DEVELOPMENT REVIEW BOARD REPORT

CASE NUMBER/ PROJECT NAME	83-DR-2005 Orange Row Condominiums		
LOCATION	7002, 7004 & 7006 E. 6 th Street, at the southeast corner of E. 6 th Street and N. 70 th Street.		
REQUEST	Request approval of a site plan and elevations for a three-unit condominium development.		
OWNER	Urbanrise Development LLC 602-214-1345	ENGINEER	USA Infrastructure LLC 480-507-6792
ARCHITECT/ DESIGNER	Rob Paulus Architect, Ltd. 520-624-9805	APPLICANT/ COORDINATOR	Liz Farkas Rob Paulus Architect, Ltd. 520-624-9805
BACKGROUND	<p>Zoning.</p> <p>The site is zoned C-3 DO (Highway Commercial) within the Downtown Overlay. The Downtown Overlay recognizes the uses permitted by the underlying zoning district and also encourages residential and multi-family residential uses to locate in the Downtown area and establishes these as permitted uses, even within the Commercial District. The intent of the Overlay is to establish mixed-use developments through the provision of a 0.5 FAR density bonus to a maximum FAR of 1.3 for non-residential uses. Included as mixed-use developments by the Downtown Overlay are commercial and residential uses and provisions for stand-alone residential uses. T

LANDSCAPE PLAN

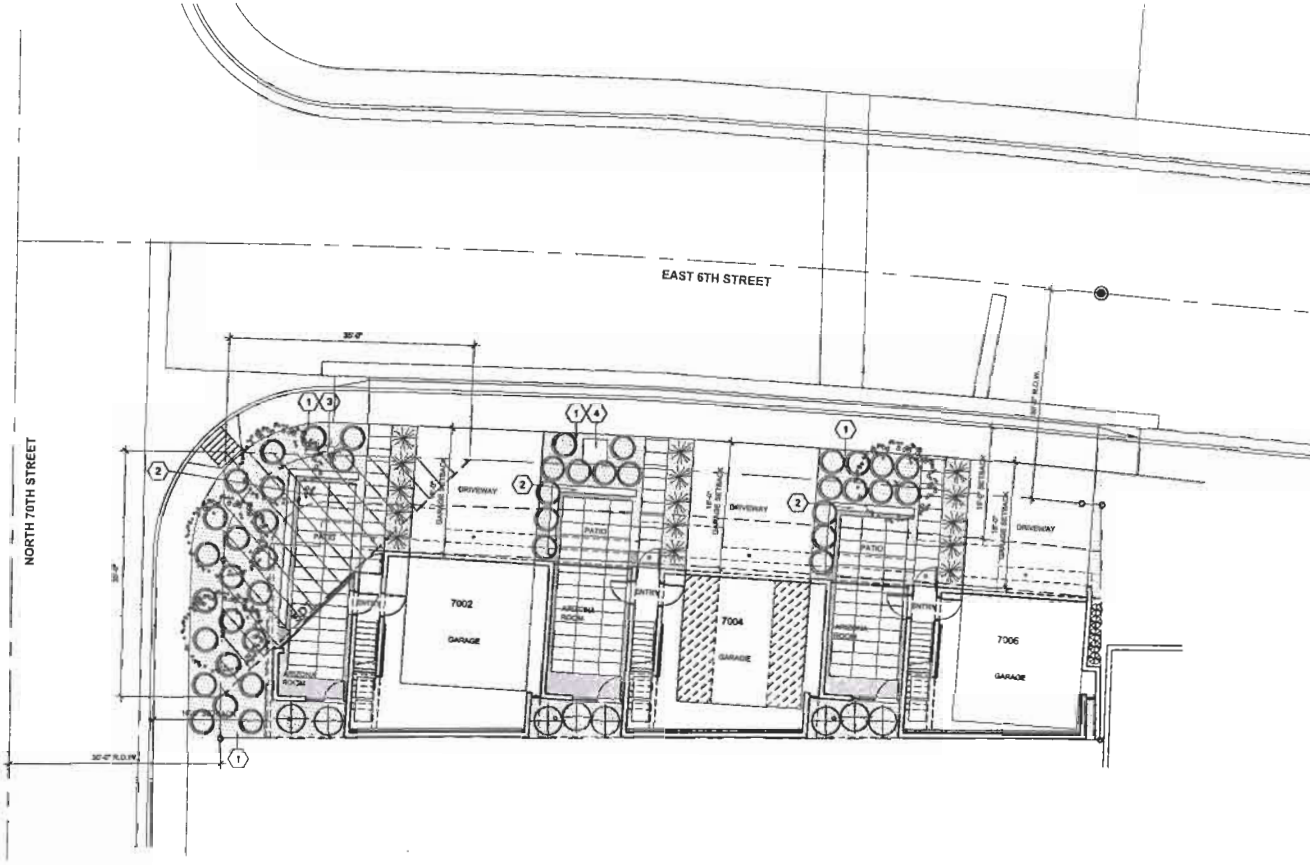
11. *The maximum floor area ratio for this project shall not exceed that which is indicated on the site plan, provided by Rob Paulus Architect, Ltd., and dated 3/31/06.*
12. *The proposed site wall/bench located within the corner safety triangle shall not exceed twenty-four (24) inches in height from top of grade.*
13. *The applicant shall coordinate with the utility provider for this site and, if possible, provide some additional landscaping around the existing transformer on 6th Street for screening purposes. Show final solution on landscape plan to the satisfaction of the project coordinator.*

1 NORTH ELEVATION
1/8" = 1'-0"

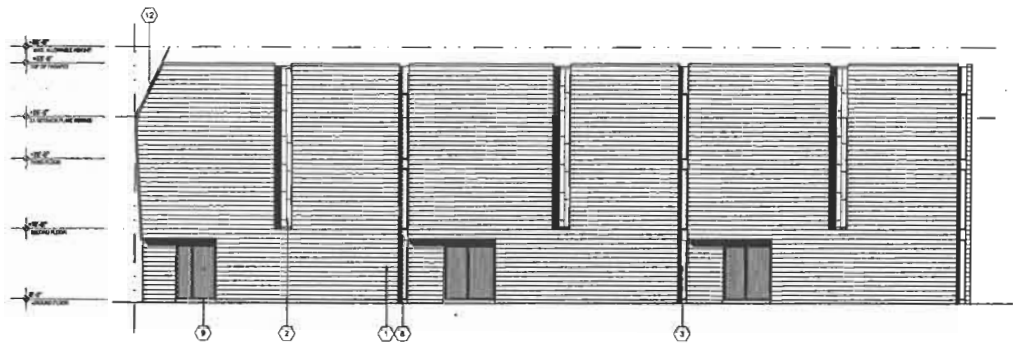
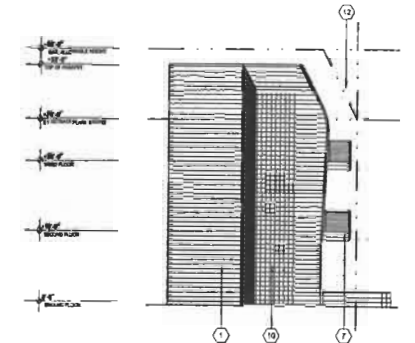
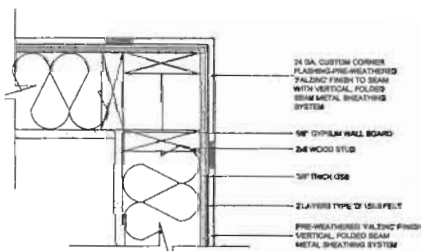
In this case, the property abuts a vacant lot with C-3/DO zoning. The staff would not be supportive of a 36-foot tall block wall at the property line for design review reasons, and the wall (with any design) requires maintenance. The relatively narrow lot precludes moving the structure inward (northerly) to facilitate maintenance. However, the owner must have some mechanism for maintenance of the wall. As such, staff has prepared a draft stipulation for Board consideration which would require the applicant to obtain an easement from the

- 21. Flagpoles, if provided, shall be one piece, conical, and tapered.
- 22. *Prior to final plans submittal, the applicant shall provide evidence of a written agreement with the adjacent property owner to the south, i.e. private easement that provides access for basic maintenance of the proposed building at the zero lot line, to the satisfaction of the project coordinator.*
